**SUBMITTAL OF PLANS FOR CAPPING THE REMAINDER OF VAULT ONE, Z-
AREA SALTSTONE FACILITY (IWP-217) (U)**

OCP No. C-DCP-Z-93001

Since the original design for capping cell A of Saltstone Vault No. 1, as shown on drawing C-CC-Z-0010, has been changed due to lessons learned during the construction phase of cell A, the remaining cells (B through F) need a new design.

TITLE
**SAVANNAH RIVER SITE-200Z AREA
 DEFENSE WASTE PROCESSING FACILITY-SALTSTONE**
**SALTSTONE VAULT NO.1
 PERSONAL PROTECTION LAYERS
 PLAN, SECTIONS AND DETAILS (U)**
STRUCTURAL CONCRETE

SALTSTONE VAULT #1 ISOMETRIC

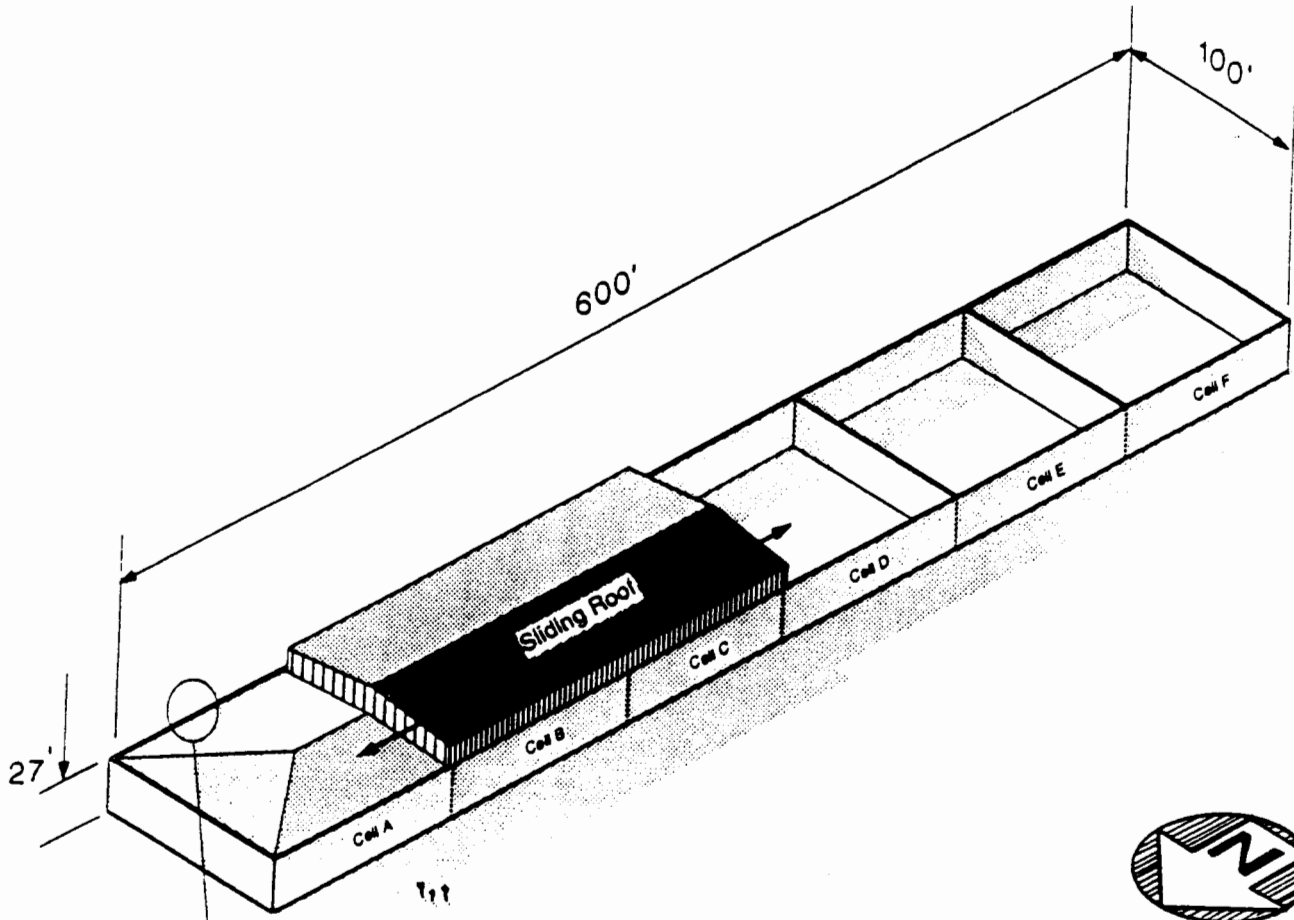
See Detail 1 for an enlargement of this area.

DETAIL

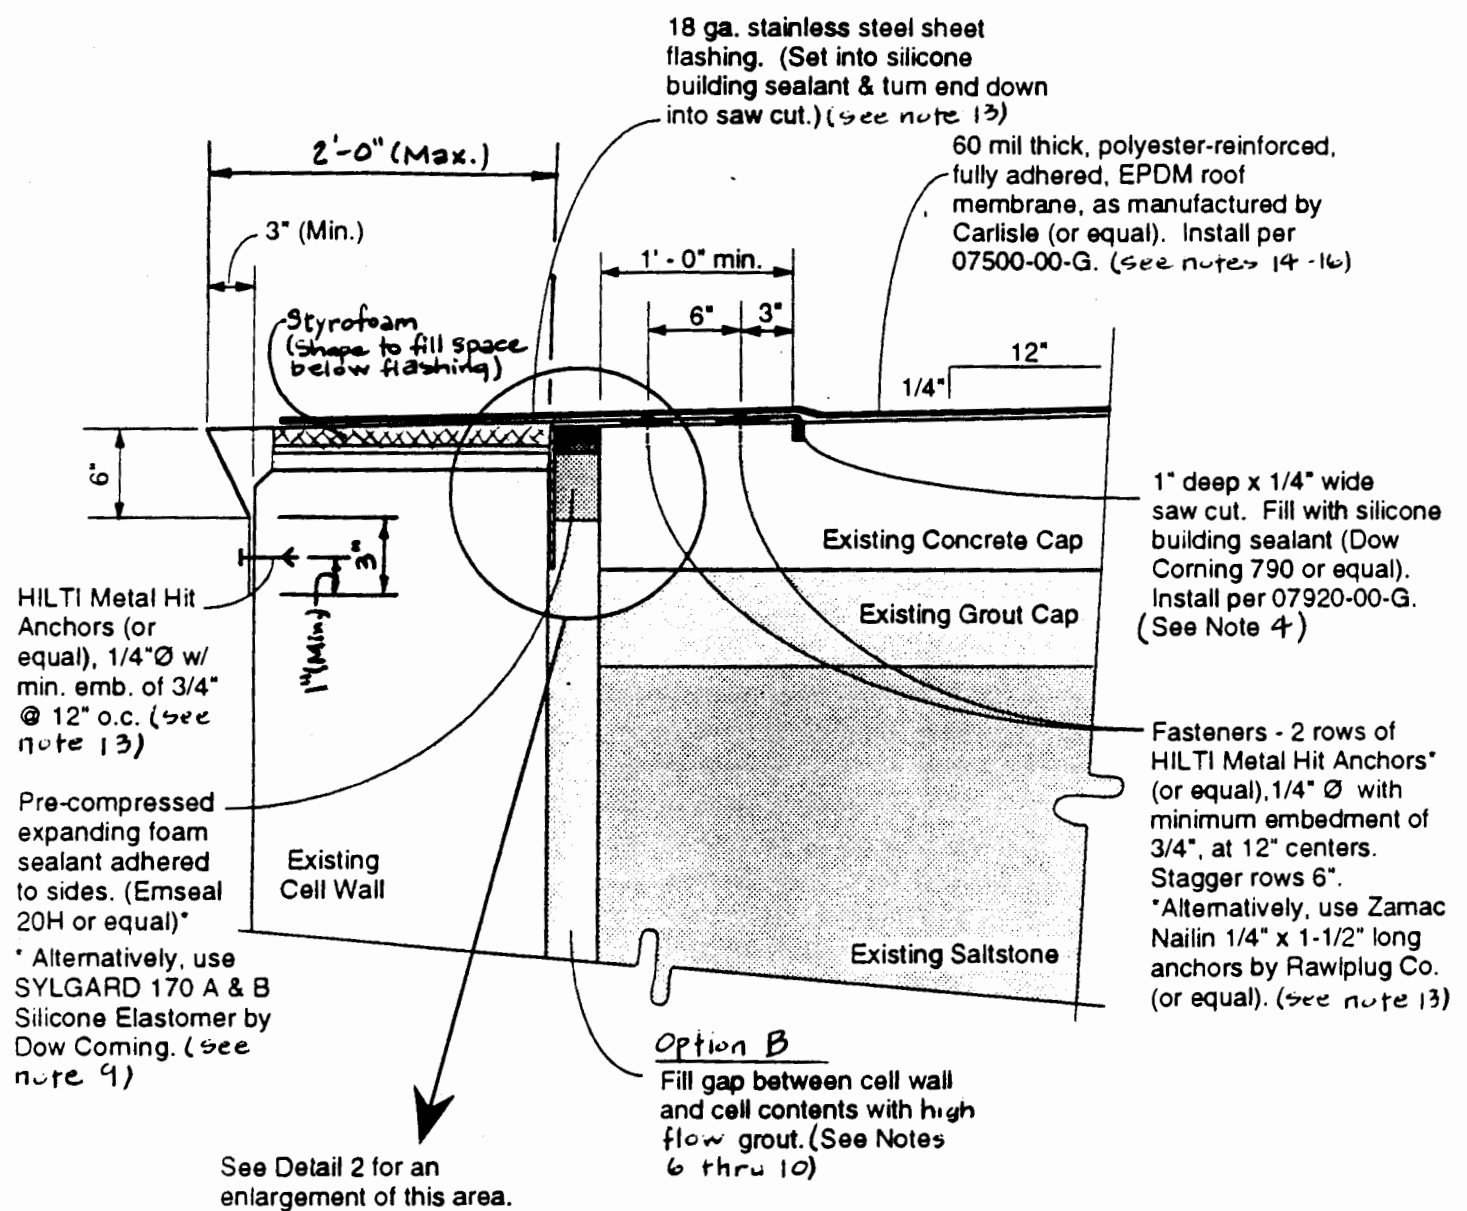
3. Place the 6" reinforced concrete layer in accordance with Drawing No. C-CC-Z-0010. **Option A:** Place a 2" x 5-1/2" expansion joint strip and a 2" wide x 1/2" deep (max.) filler strip (on top), wrapped in a plastic bond-breaker sheet, at the edge of this layer. These 2" wide strips shall be placed flush with the inside face of the cell wall and up to the top of the existing vertical embedded plate.

5. **Option A:** Remove the 2" x 1/2" filler strip and bond breaker (if used) after the concrete has cured for a minimum of 24 hours. Insert a new bond breaker sheet in this notch and fill with silicone building sealant (Dow Corning 790 or equal).

DETAIL

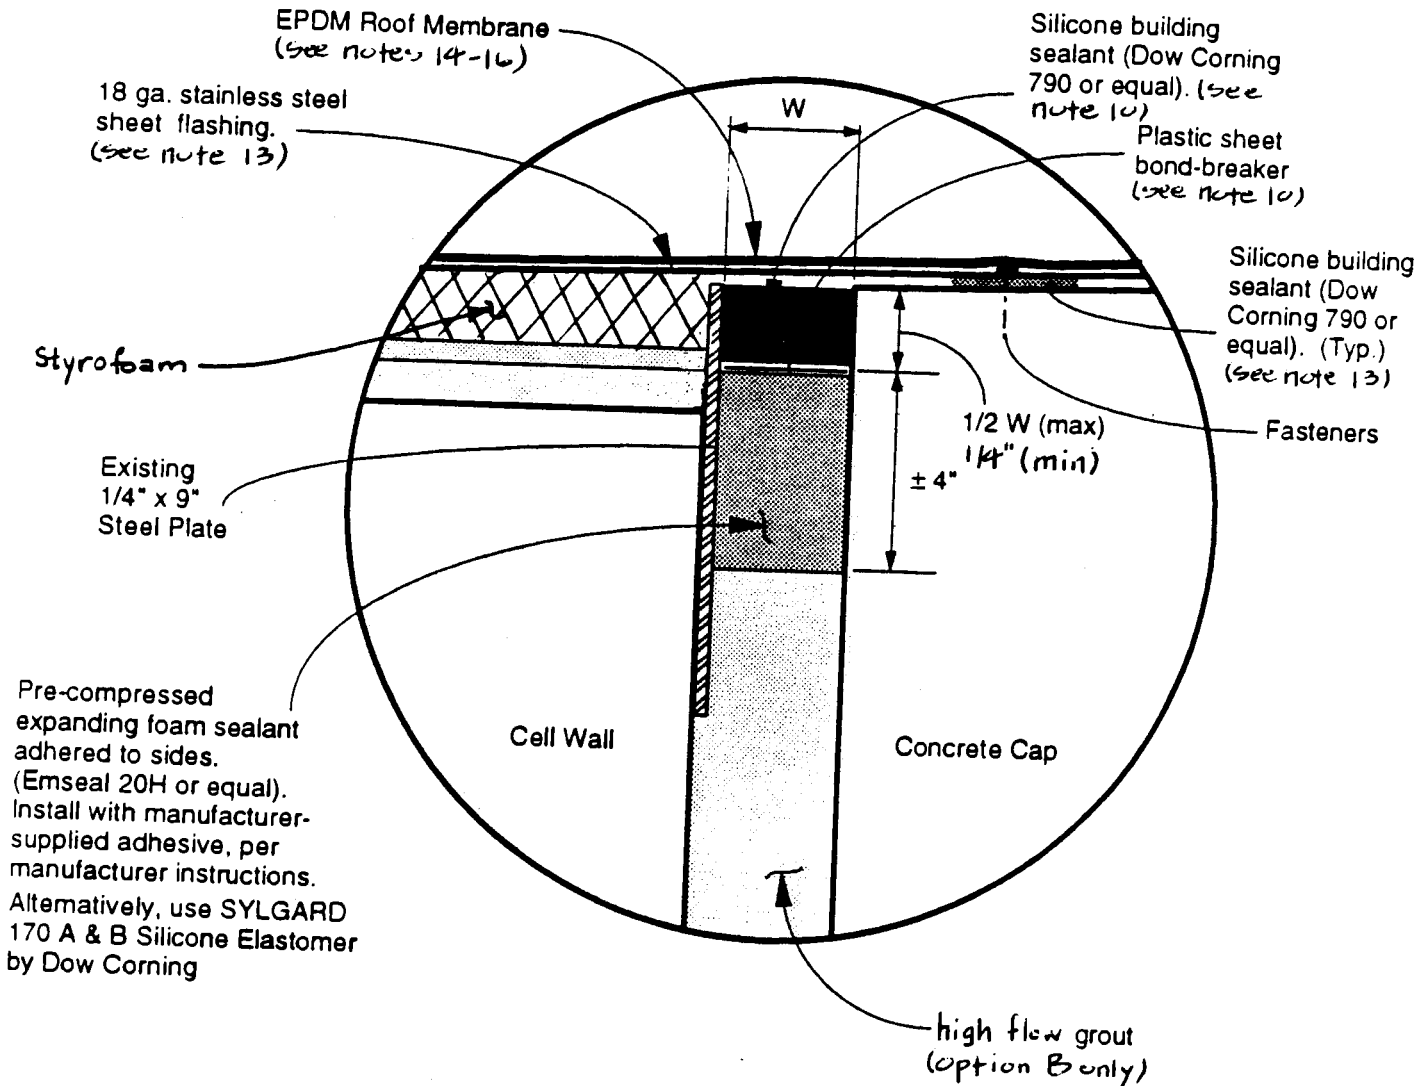
13. Install 18 gage stainless steel sheet flashing on top of concrete cap, in a bed of silicone (Dow Corning 790, or equal) on the east and west sides of the cell (and also the south side of Cell F). Turn upper end of top flashing down into the saw-cut groove. Flashing shall be attached to the concrete cap on top by two rows of HILTI Metal HIT 1/4" Φ anchors, with a minimum embedment of 3/4 inch; alternatively, use Rawlplug Zamac Nailin anchors, 1/4" Φ x 1-1/2" long, or other equal. Stagger the two row of fasteners by 6 inches. The flashing shall be attached on the outside face of the vault wall with HILTI Metal HIT anchors, 1/4" Φ with 3/4" minimum embedment @ 12" o.c.. Lap flashing joints 2 inches minimum and seal laps with silicone building sealant (Dow Corning 790 or equal). Fill saw-cut groove completely with silicone building sealant, and tool top of sealant flush with top edges of saw-cut groove.
